To: Members of Dublin City Council
From: Dana L. McDaniel, City Manager
Date: February 4, 2020
Initiated Jennifer M. Rauch, AICP, Interim Planning Director
By: Claudia D. Husak, AICP, Senior Planner
Chase J. Ridge, AICP Candidate, Planner I
Re: Ordinance 07-20
Rezoning with Preliminary Development Plan of +/- 24 acres from PUD, Planned Unit Development District (Tartan Ridge, Subareas D1, E and F) to PUD, Planned Unit Development District (Tartan Ridge, Subarea F) for the future development of up to 56 single-family homes and 7.9 acres of open space. The site is north of McKitrick Road and east of Hyland-Croy Road (Case 19-084Z/PDP)

This Ordinance is a request for review and approval of a rezoning with preliminary development plan of a 24-acre site within the Tartan Ridge PUD to allow for the future construction of up to 56 single-family homes and approximately 7.9 acres of open space.

City of Dublin, Ohio Preliminary Development Plan

Exhibit 'C-1'

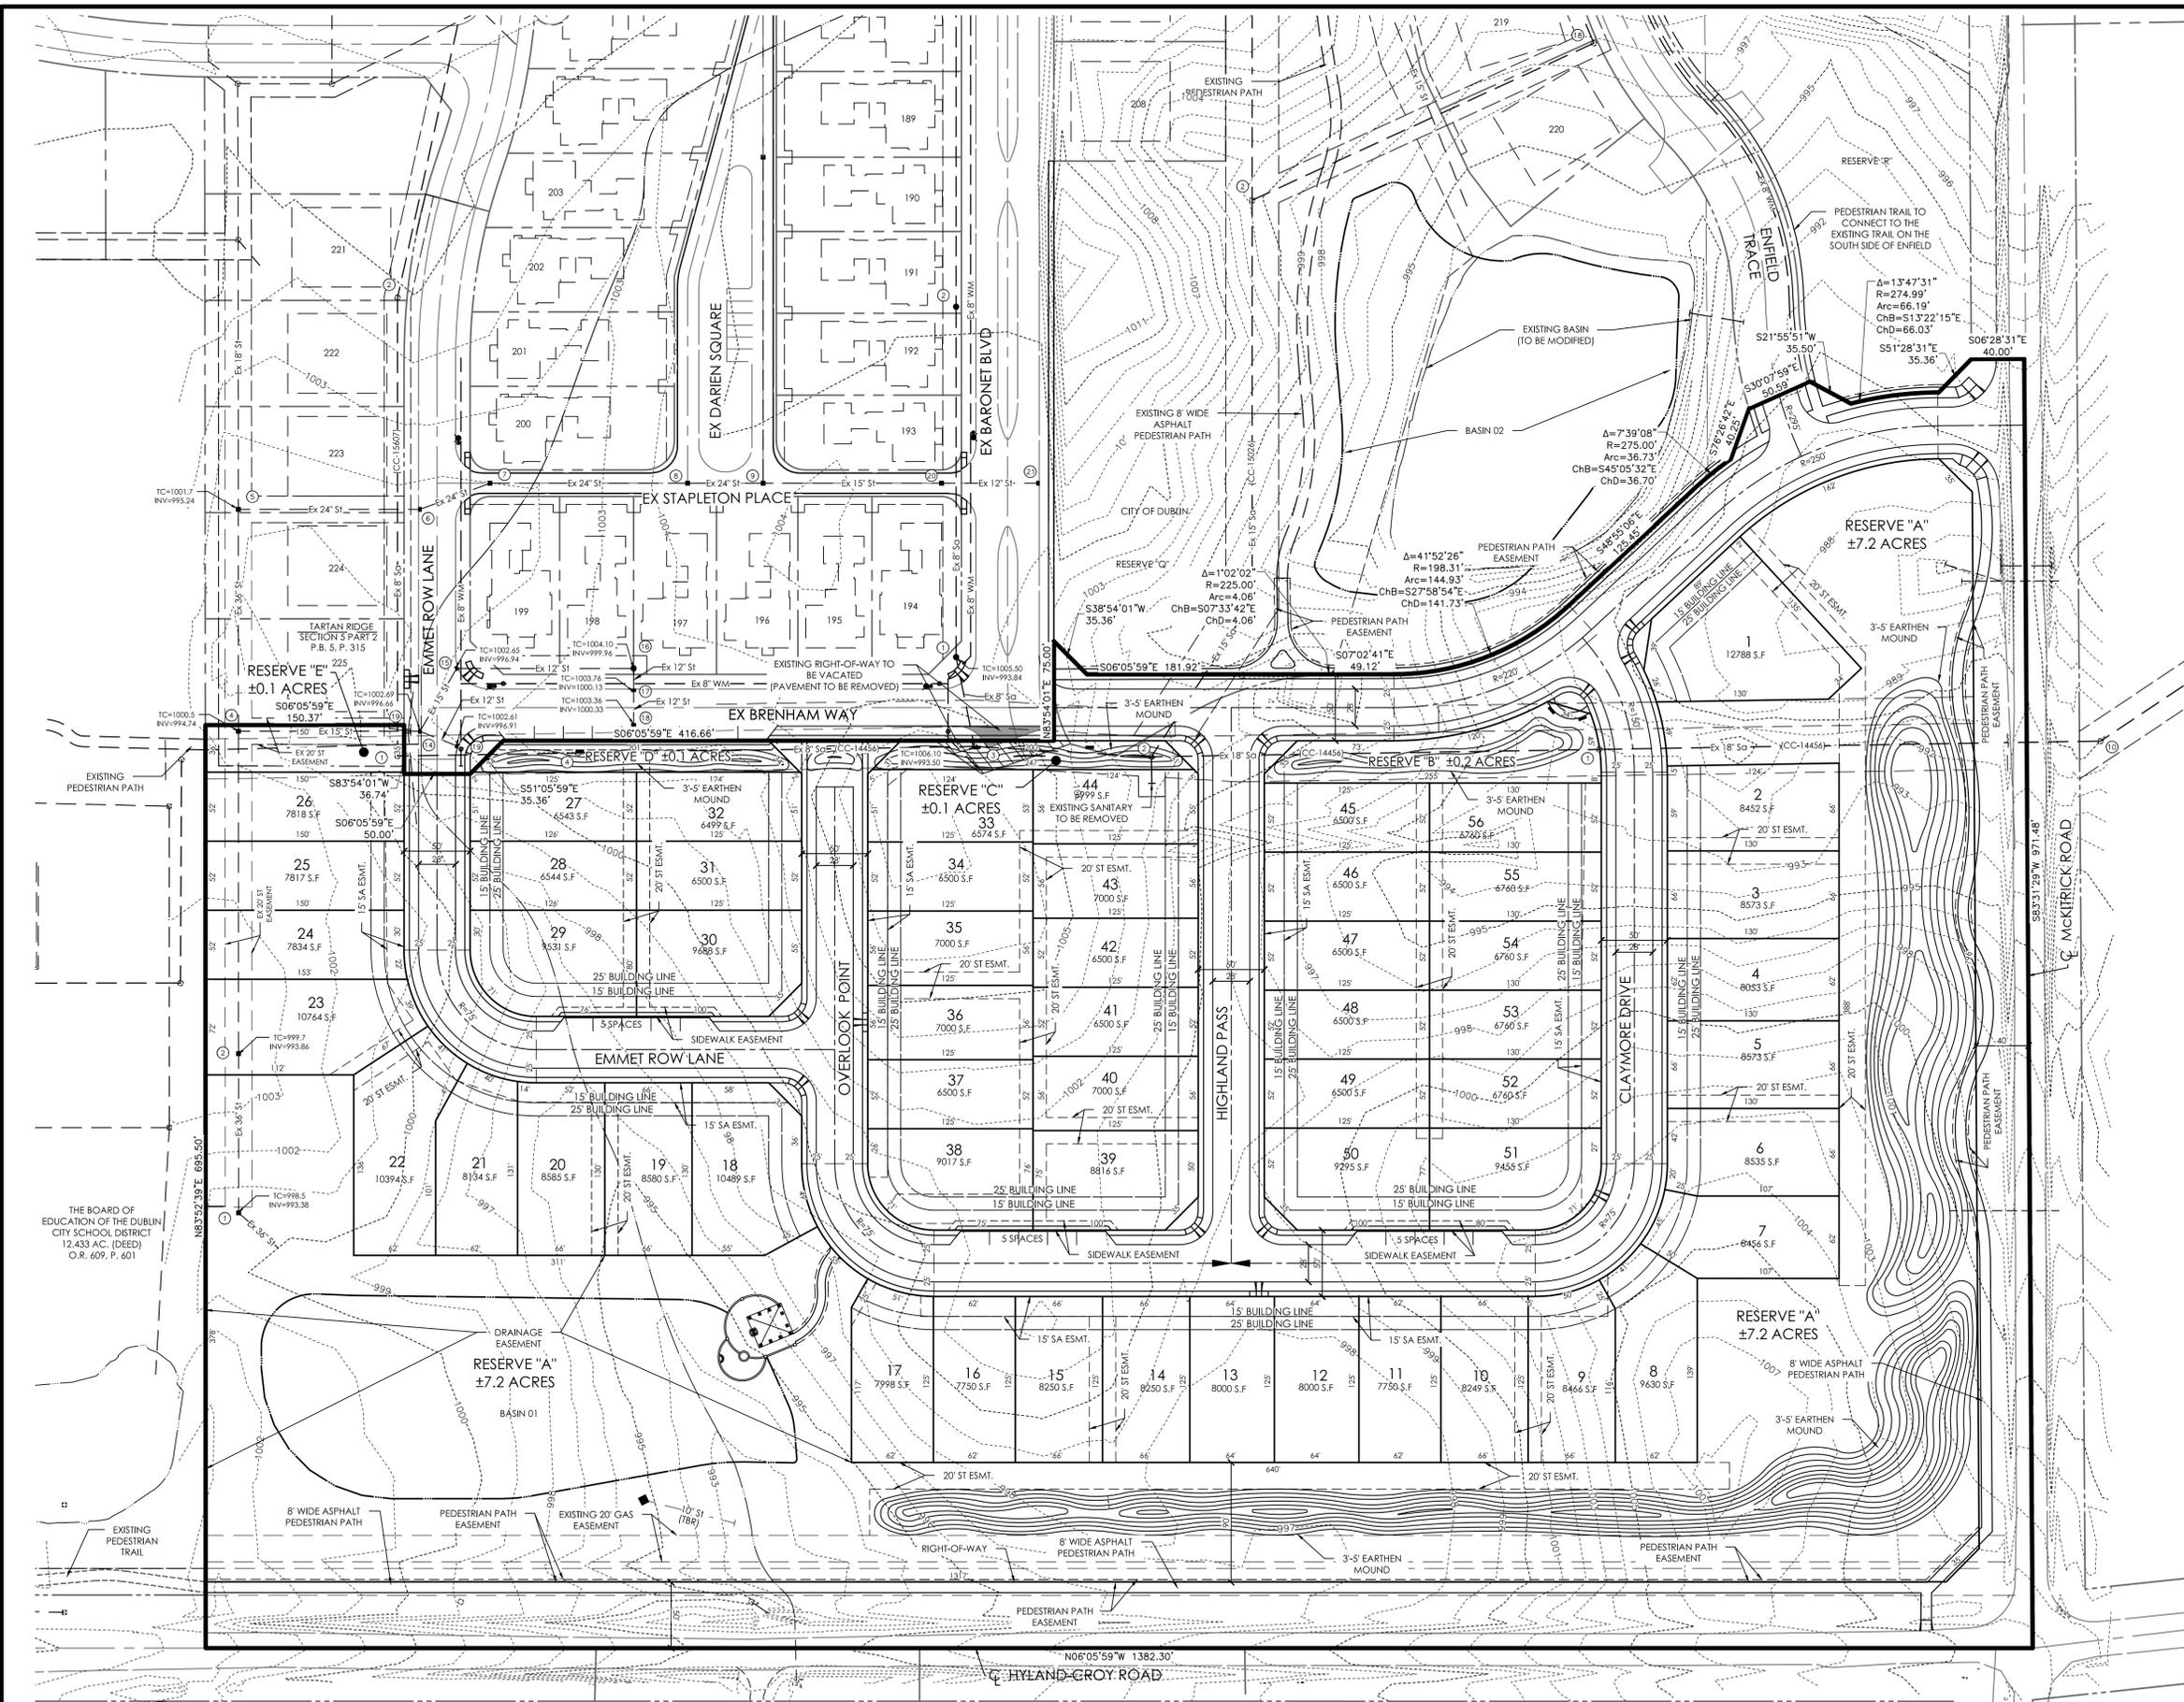
Ms. Newell referred to Exhibit C-1, which is an EMH&T plan. Running along Hyland-Croy Road, there are a number of dashed lines; what do they denote?

The Overlook at Tartan Ridge - Preliminary Landscape Plan

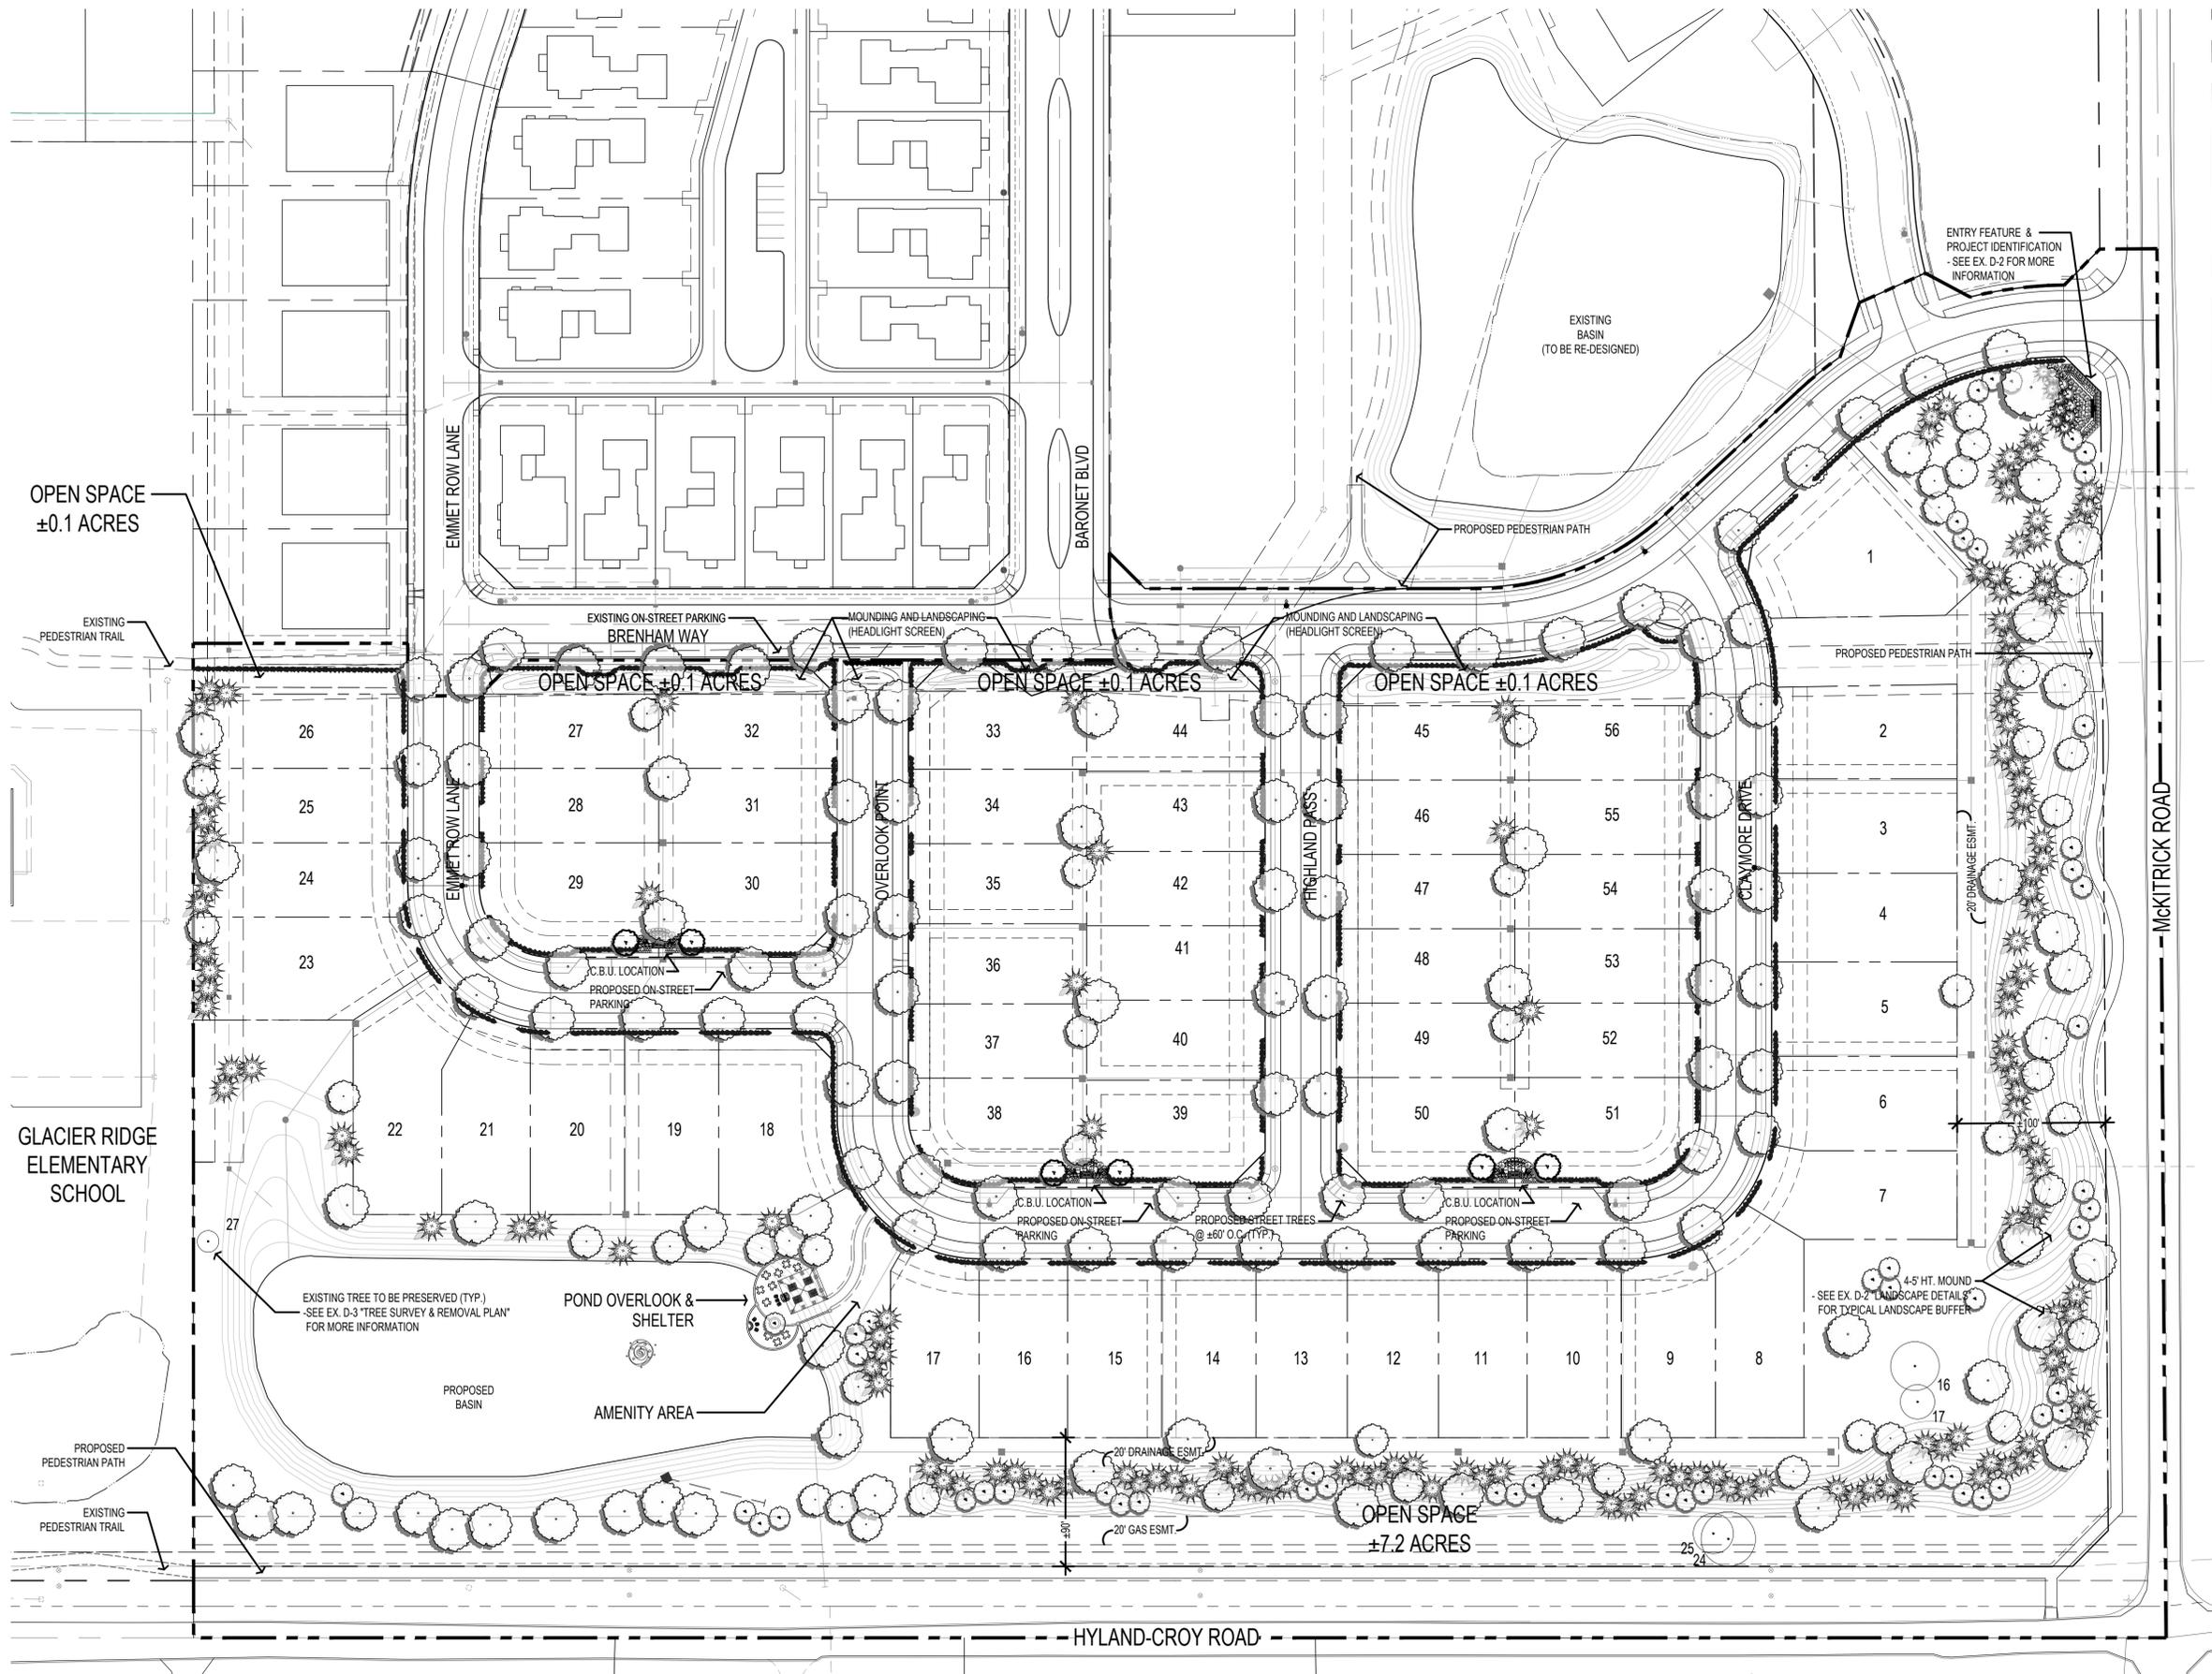
- 1) That the preliminary development plan Subarea map be revised to include the existing storm water management pond in the southeast portion of the site that is to be redesigned, prior to Council review;
- 2) That the applicant continue to work with Staff to ensure that the street names and naming method is appropriate;
- 3) That the applicant work with Staff to clarify HOA membership;
- 4) That the applicant remove the dry basin, add green space in the area and landscape material in the area, subject to Staff approval;
- 5) That the applicant provide opaque landscaping on the mound along Hyland Croy Road

- 1) That the Preliminary Development Plan subarea map be revised to include the existing stormwater management pond in the southeast portion of the site that is to be redesigned, prior to Council review;
- 2) That the applicant continue to work with Staff to ensure that the street names and naming method are appropriate;
- 3) That the applicant work with Staff to clarify HOA membership;
- 4) That the applicant remove the dry basin, add green space in the area and landscape material in the area, subject to Staff approval; and
- 5) That the applicant provide opaque landscaping on the mound along Hyland Croy Road.
